Regulatory Impact Analysis,
Oxides of Nitrogen Pollutant Specific Study
and
Summary and Analysis of Comments

Control of Air Pollution from New Motor
Vehicles and New Motor Vehicle Engines:
Gaseous Emission Regulations for 1987
and Later Model Year Light-Duty Vehicles,
and for 1988 and Later Model Year
Light-Duty Trucks and Heavy-Duty Engines;
Particulate Emission Regulations for 1988
and Later Model Year Heavy-Duty Diesel Engines

March 1985

Environmental Protection Agency
Office of Air and Radiation
Office of Mobile Sources

Figure 2-1

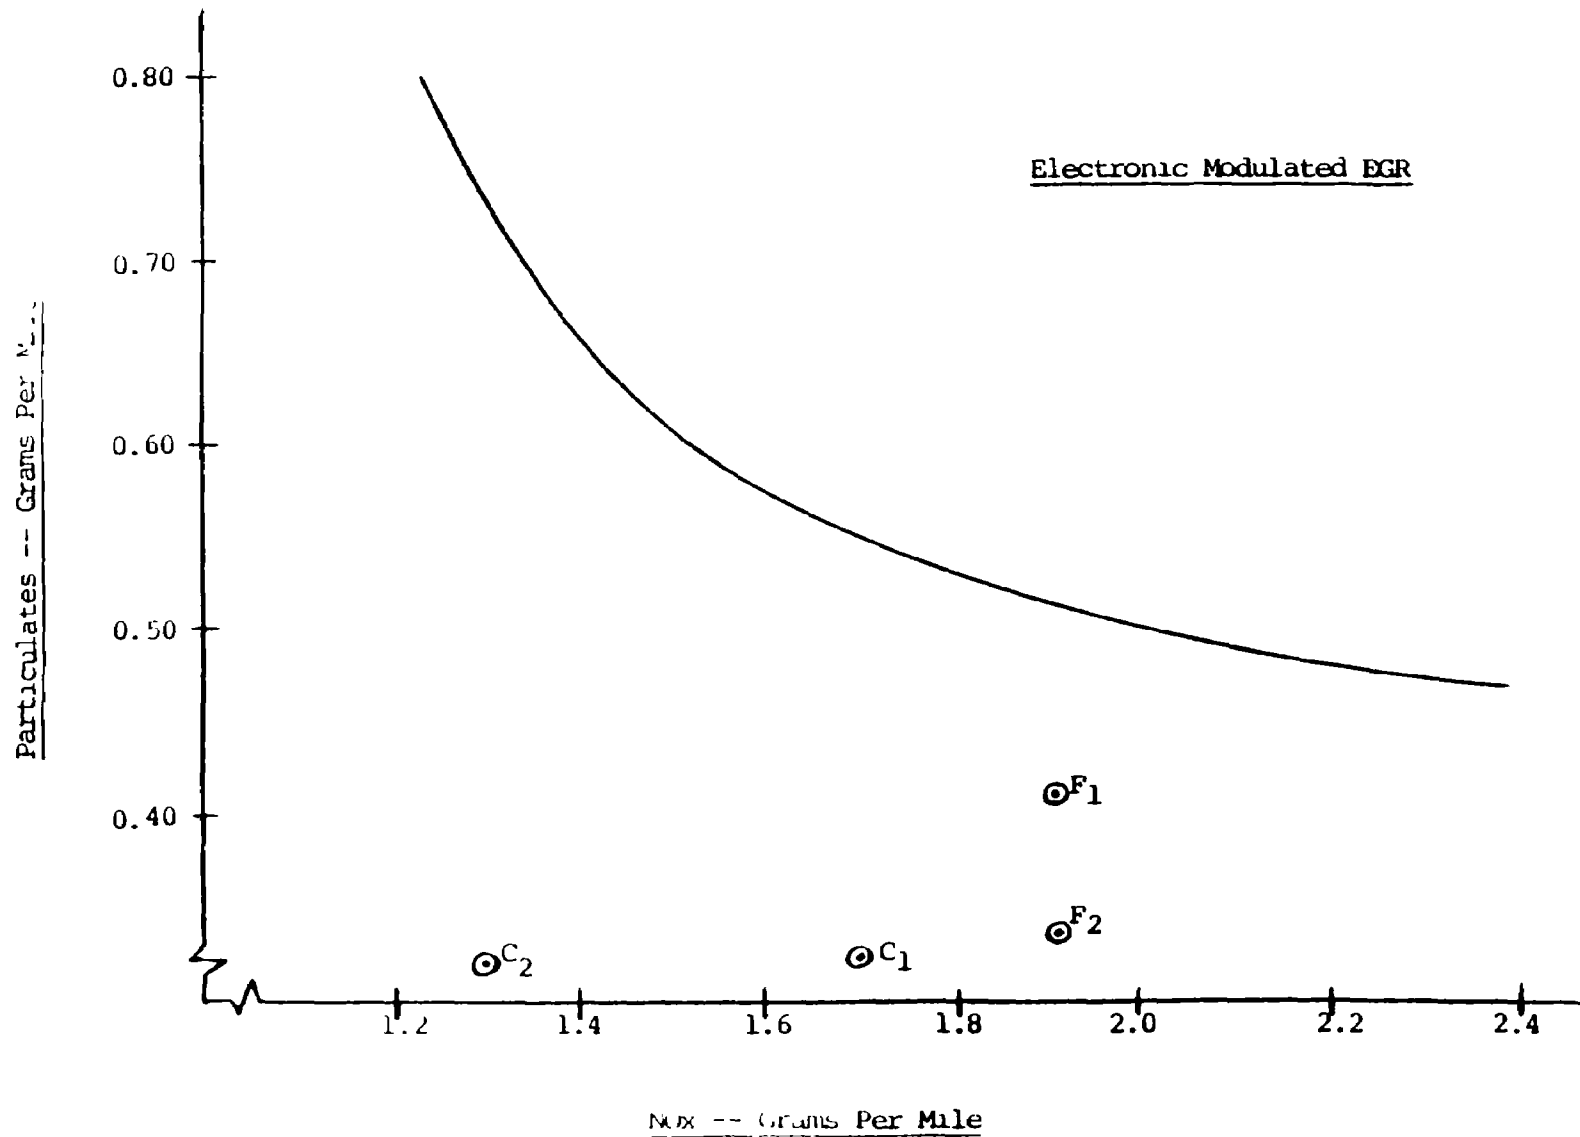
In responding to the comment from GM, EPA has plotted 1985 model year certification data for the Federal and California versions of the 6.2 liter GM engine on the curve provided by GM in its Figure III-C-1 (reproduced here as Figure 2-1). These values are shown as F₁ and F₂ (1.90 g/mi NOx, 0.41 g/mi particulate and 1.90 g/mi NOx, 0.34 g/mi particulate) for the two federal vehicles using EGR and as C₁ and C₂ (1.7 g/mi NOx, 0.32 g/mi particulate and 1.3 g/mi NOx, 0.32 g/mi particulate) for the two California engines using electronically controlled EGR. As can be seen from Figure 2-1, NOx and particulate emissions actually being achieved are substantially lower than the generalized curve presented by GM. In addition, because the 6.2 liter GM engine is already very close to the particulate standard on an engine-out basis, EPA can see no basis for GM's concern about meeting the particulate standard. The application of particulate traps

approximately percent of these engines would, with averaging, secure compliance with the 0.26 g/mi standard. EPA concludes that the NOx/particulate curve supplied by GM is not applicable to current versions of its 6.2 liter engine, and that GM should have no difficulty meeting a 1.7 g/mi standard with this engine.

Figure 2-2

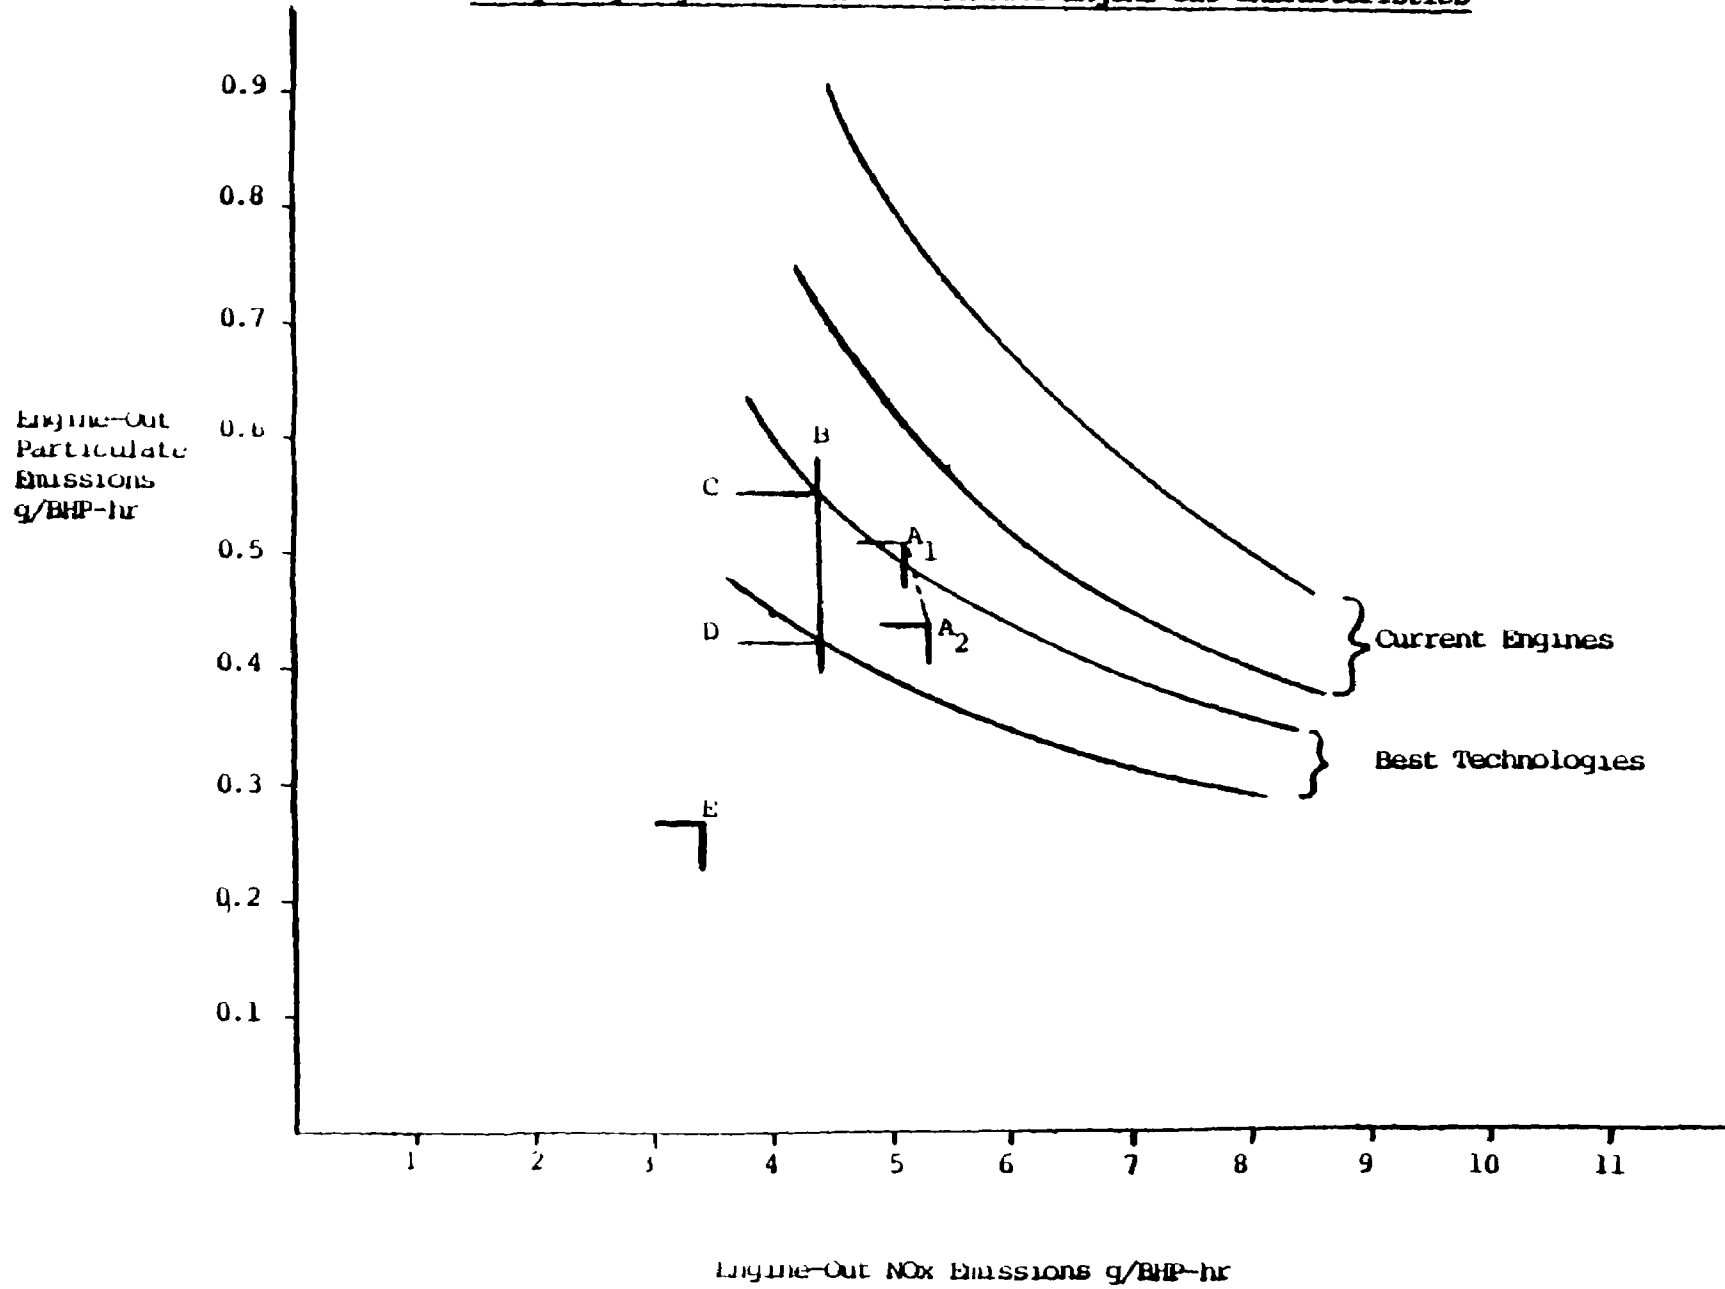
However, some confidential data were made available indicating the combined effect of a number of these techniques (e.g., increased injection pressure and enhanced aftercooling), as well as the projections of the levels feasible in this timeframe. While such data cannot be used to directly determine the fullest potential of one or more technologies, they do represent the most quantitative set of estimates available. Some degree of evaluation can be applied using the estimates of the Draft RIA. To facilitate their use here, these data have been combined into a single figure (Figure 2-2) which shows both current levels of NOx and particulate emissions and the manufacturers anticipated achievable levels. Superimposed on the best achievable emission control projections are the range of low-mileage targets as previously developed for the 6.0/0.60 standards (points A₁ and A₂) and the midpoint of the low-mileage targets for the engine standards of 4.0/0.40 (point E). A low-mileage target level of 4.2-4.6 g/BHP-hr for a NOx standard of 5.0 g/BHP-hr (vertical lines B) was also developed by the same procedure and its midpoint shown for comparison purposes. Particulate level

With respect to particulate, the range of expected low mileage engine-out particulate levels corresponding to the target level required for a NO_x standard of 5.0 g/BHP-hr would be 0.42-0.54 g/BHP-hr (levels C and D in Figure 2-2). If it is assumed that trap-based standards are implemented in 1991 and 1994 (i.e., pressure to control particulate continues through the 1994 timeframe), then it is likely that progress will continue to be made in reducing engine-out particulate levels down to the lower best technology curve, resulting in an engine-out particulate level of 0.43 g/BHP-hr by 1994. If stringent 1991 non-trap particulate standard were implemented in 1991, it should also be able to reduce engine-out levels to 0.42 g/BHP-hr, but three years earlier. Thus, at best, a 1991 non-trap standard 0.50 g/BHP-hr appears achievable.
